Project: Implementation sewer system south –west Amman/Jordan
Construction of Sewer Networks for Selected Naur Areas Package1- (3) Lots

Contract No : 36/2022

Subject: Addendum NO.4

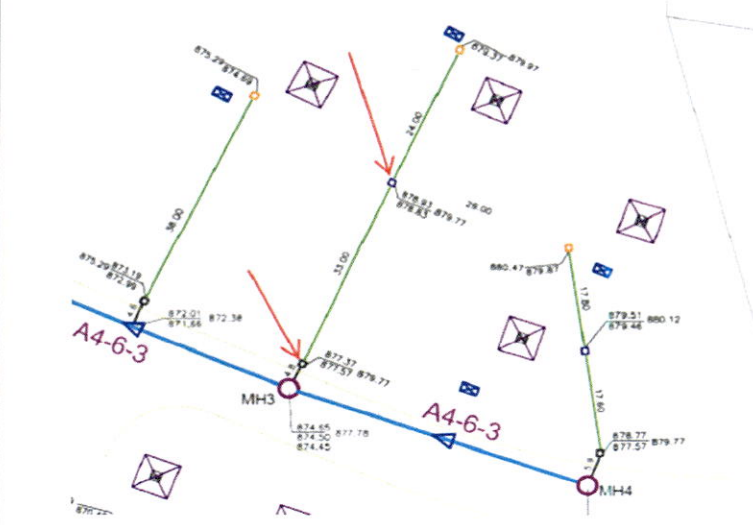
20.	Please extend the submission date by 3 more weeks as our inquiries is still not answered to date.	Refer to the answer to query 1.
21.	<p>For the house connection works, the plan drawings show two types of proposed manholes for house connections—one marked in black and another in magenta. Could you please confirm if either or both manholes are within the contractor's scope? It appears that BOQ item no. 2.1.1 does not include any manholes or inspection chambers in the scope for house connection works.</p> <p>Additionally, the drawings indicate two colored lines (black and green) for 160 mm diameter house connection pipes. Could you confirm if these pipes are part of the contractor's scope as well?</p>	<p>The Contractor shall perform the house connections (black line only) such that each house connection will be constructed up to 0.5m from the boundary of the housing unit and closed by concrete plug then backfilled as per Vol 3-Part 2-a, Technical Specifications, Section <u>"2.3.6.5" Construction Procedure of Sewer House Connection.</u> The proposed manholes (black and magenta) as well as the pipeline (green line) inside the property boundary are not part of the Contractor's scope of work.</p>
